AIRWORTHINESS BULLETIN

AWB 57-016 Issue 1 – 26 October 2017

Cessna 402C Wing Main Spar Strap Modification Non-Conformity

Photograph 1 - Engine beam reinforcement.

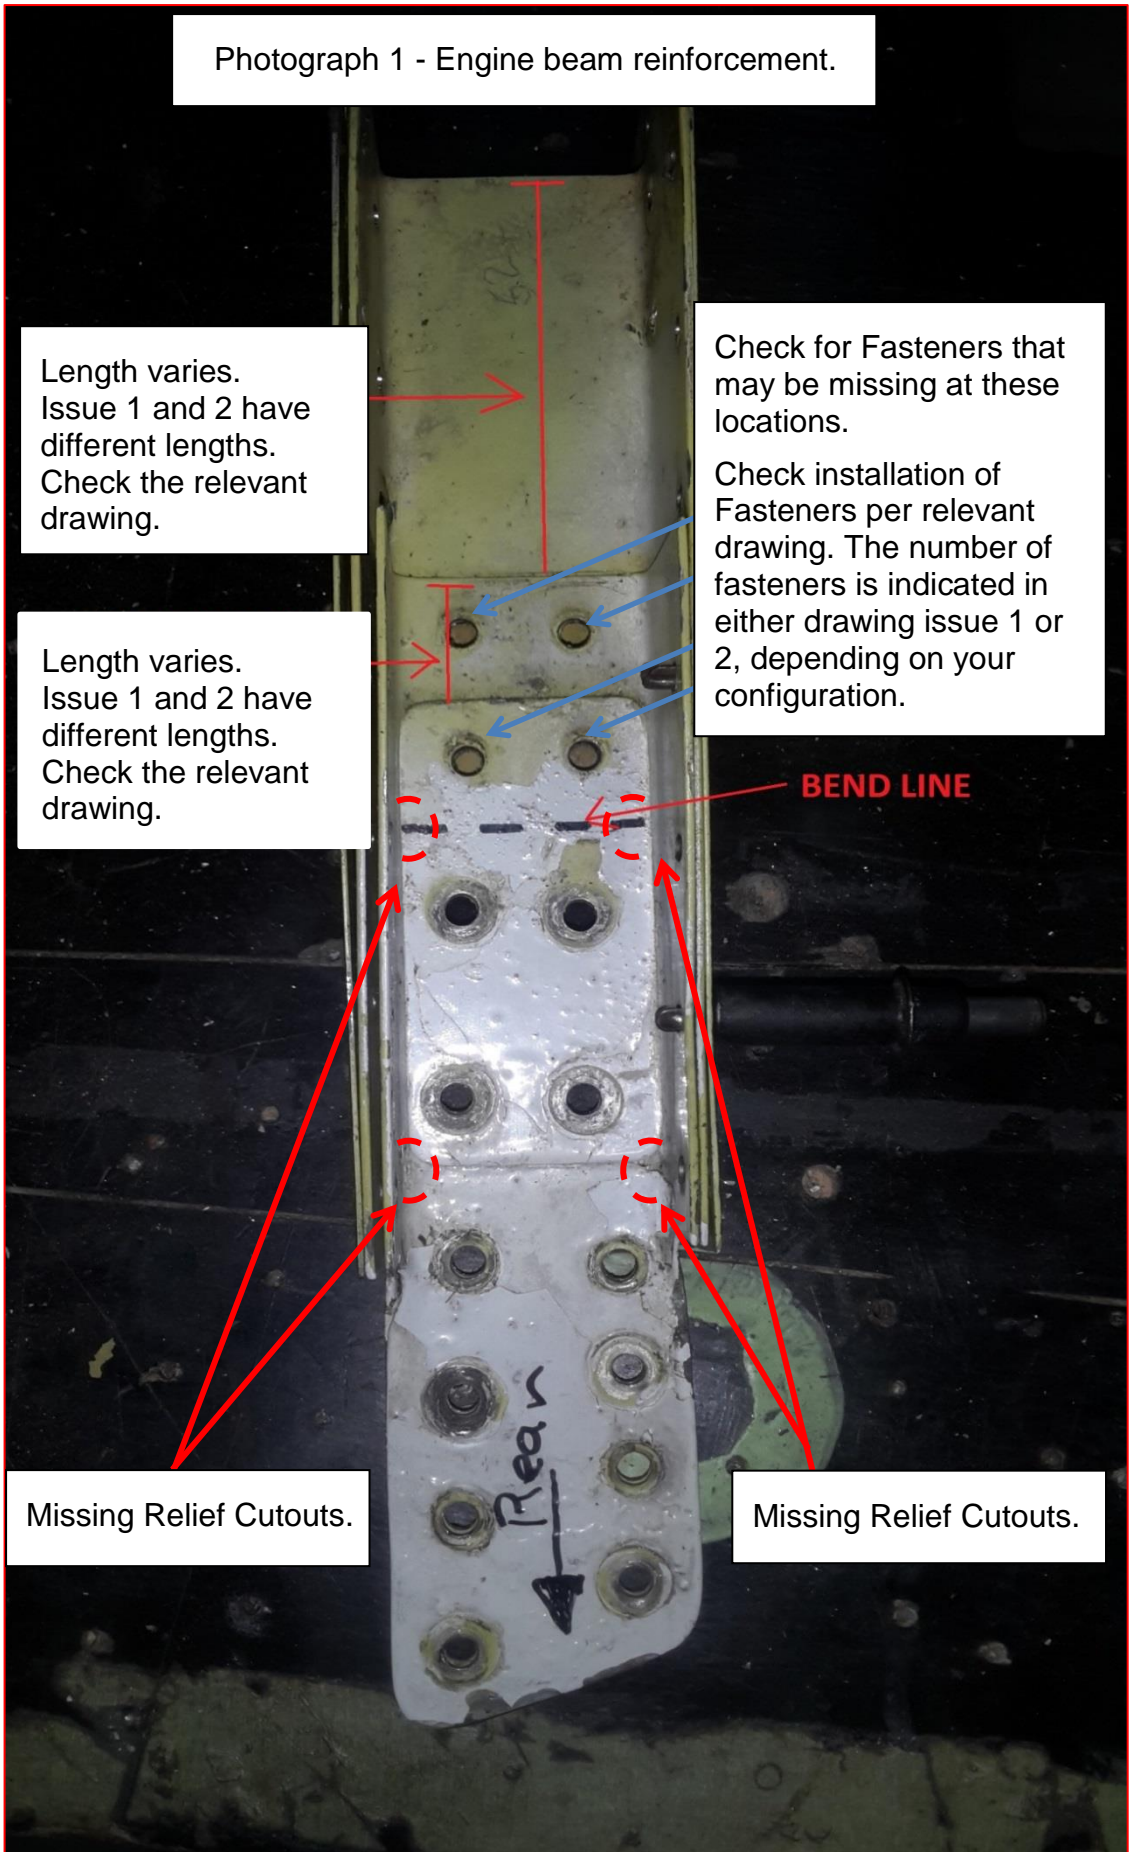
At this stage, two aircraft have been identified as potentially non-conforming with the drawings. This is being further investigated. The main discrepancy is pictured in photograph 1 on page 3, which shows the engine beam/spar strap reinforcement components that do not match the approved configuration per HDH EO 006-035. The specific features that did not conform are:

1. Absence of a bend relief radius detail in the cross hatched areas shown in photograph 1 indicated by the red arrows. The non-conforming part may have no relief cutout and has a straight edge. This should be relatively easy to detect after gaining access to the area. Check against the drawing for your particular configuration. This relief radius may/may not be required depending on whether or not there is a bend in this location.
2. Missing fasteners in location as indicated by the arrows. The required number of fasteners is indicated in either drawing Issue 1 or 2, depending on what version is installed in your aircraft.
3. The use of issue 1 of the installation drawing on a particular aircraft when only issue 2 was approved for use on that aircraft.

Length varies.
Issue 1 and 2 have
different lengths.
Check the relevant
drawing.

Length varies.
Issue 1 and 2 have
different lengths.
Check the relevant
drawing.

Check for Fasteners that
may be missing at these
locations.

Check installation of
Fasteners per relevant
drawing. The number of
fasteners is indicated in
either drawing issue 1 or
2, depending on your
configuration.

Missing Relief Cutouts.

Missing Relief Cutouts.

Photograph 2 - Issue 1 configuration. Red lines indicate bends made for Issue 2 configuration.

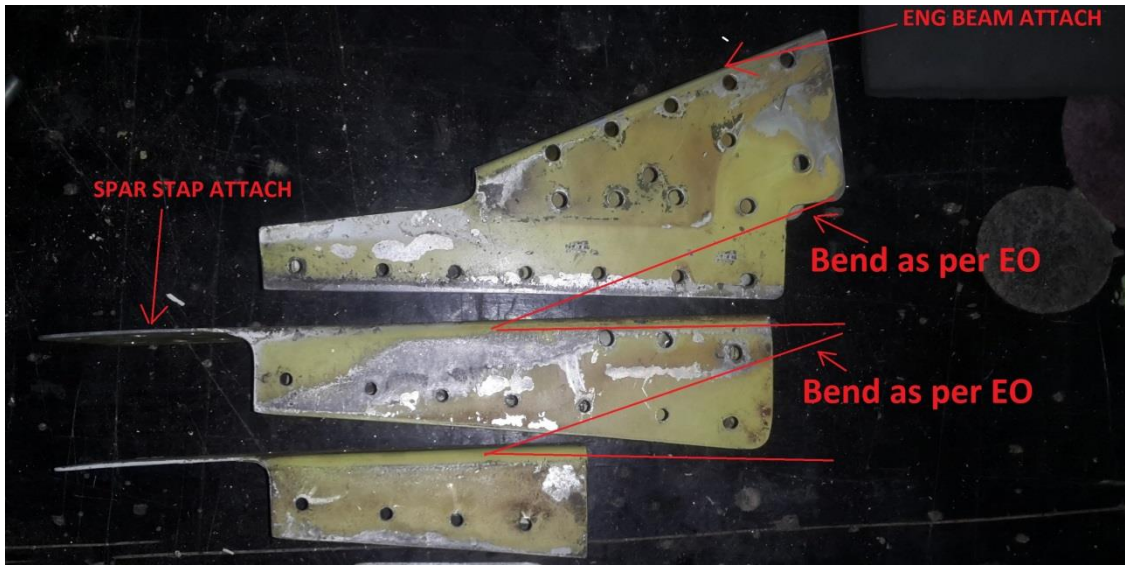
An additional discrepancy (Photograph 2) was discovered in the fabrication of other parts (P/N 006-57-10-056-001/002) in the engine beam area to Issue 1 of the drawings instead of Issue 2.
